REDBUD H&H HOMES

PLAN REVISIONS

BUYER MARKED

REDBUD - GARAGE LEFT
H&H HOMES

FRONT ELEVATION 'A'

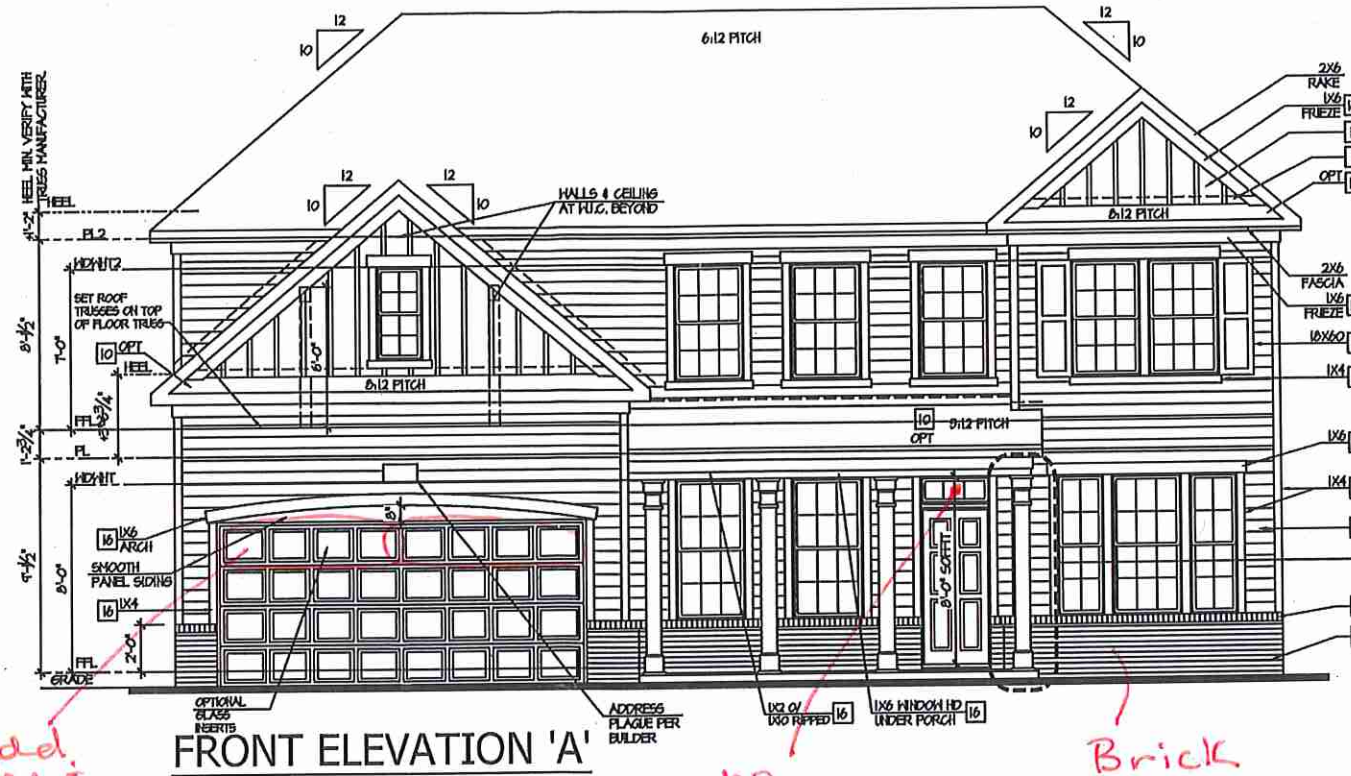
add glass + hardware

no guide

Brick

MAIN FLOOR ELECTRICAL PLAN 'A'

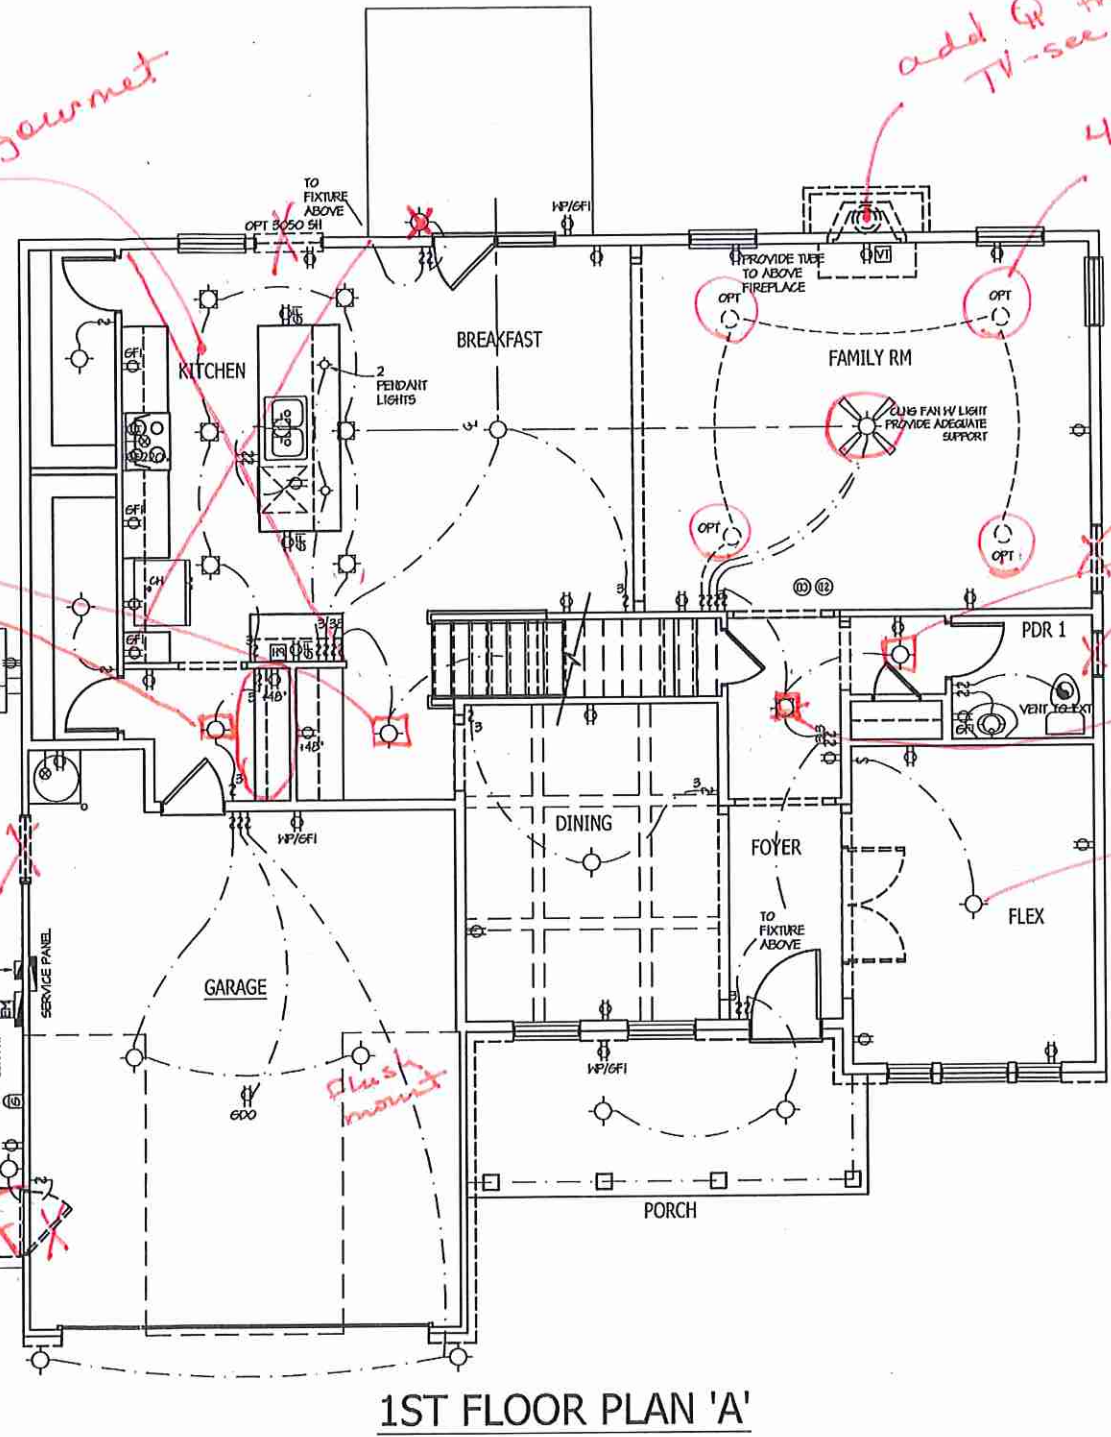
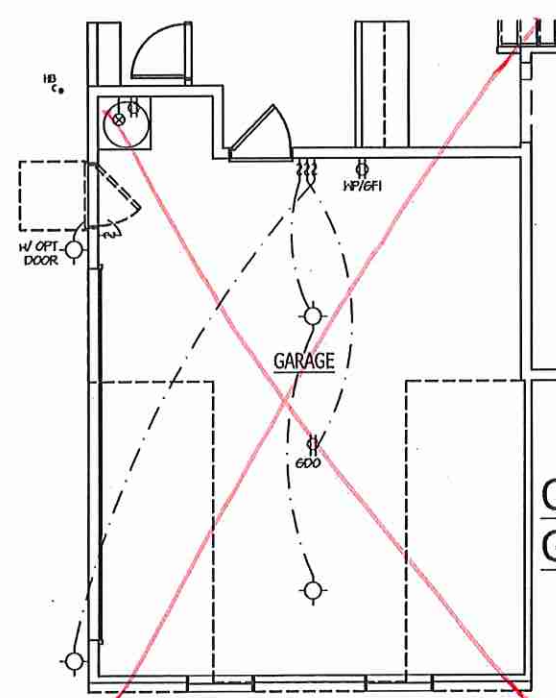
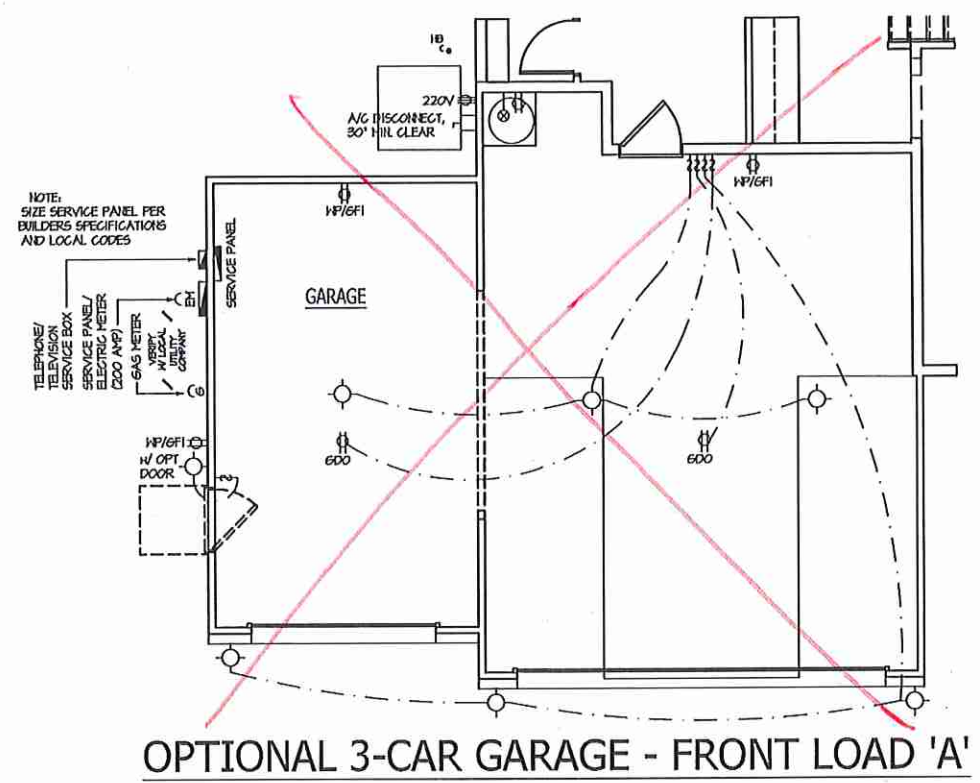
see gourmet

*add @ for TV - see CPE plan
4 Recessed cans w/ Dimmer*

provide for ceiling fan

flush mount

out swing

UPPER FLOOR ELECTRICAL PLAN 'A'
 GARAGE LEFT

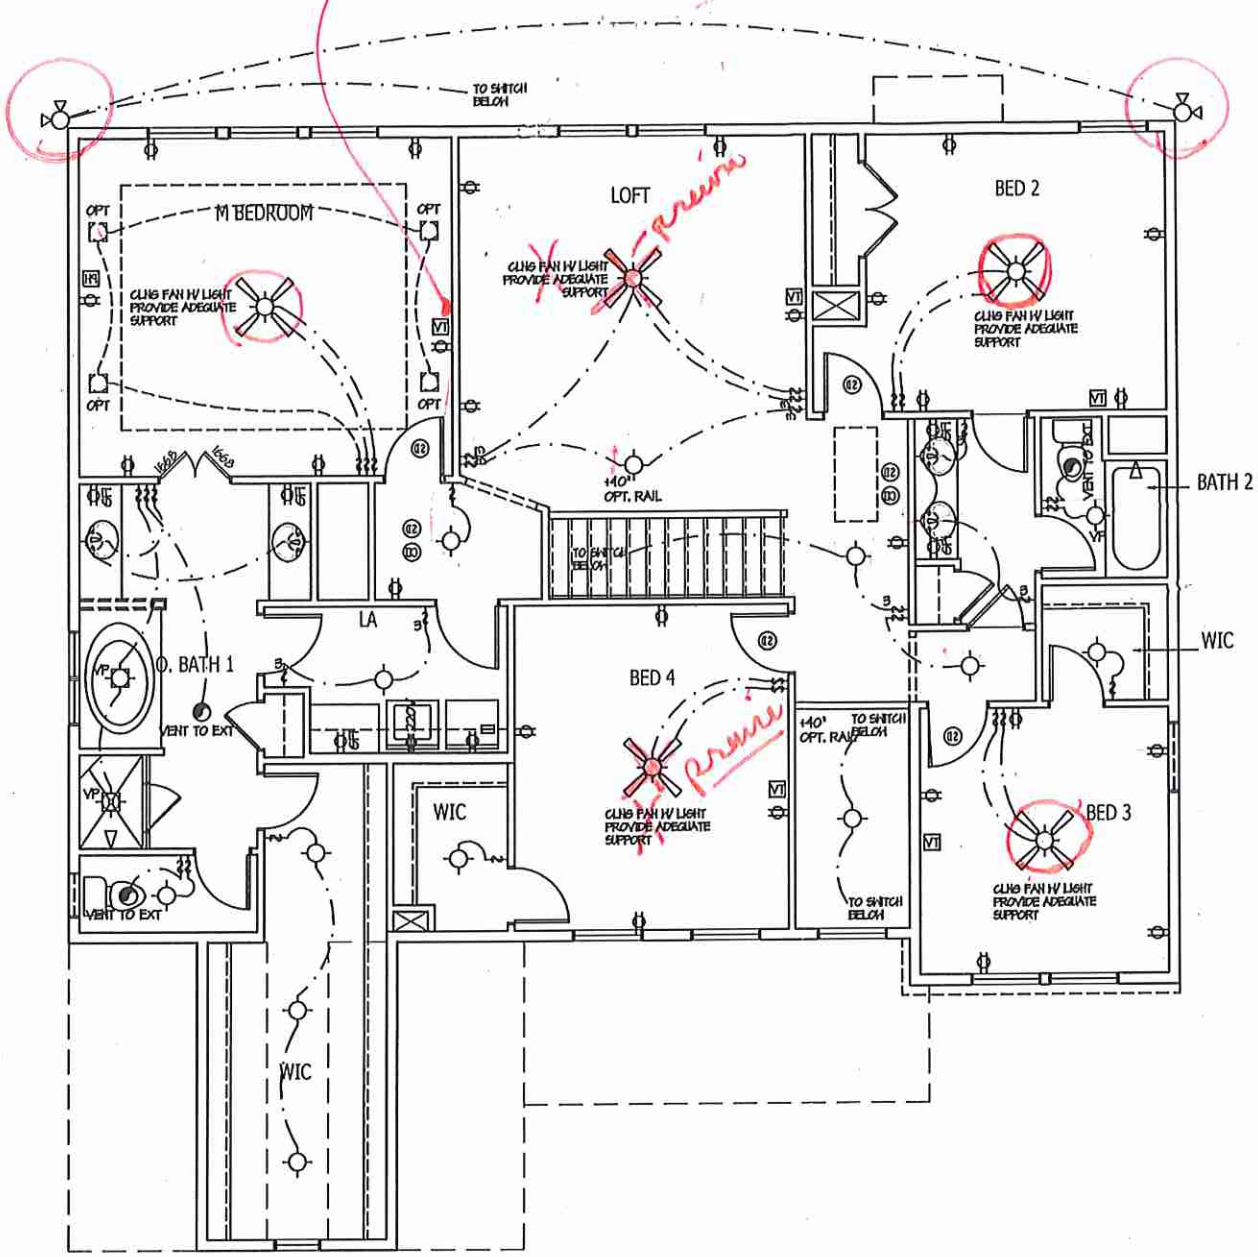
add @ 55" fr TV
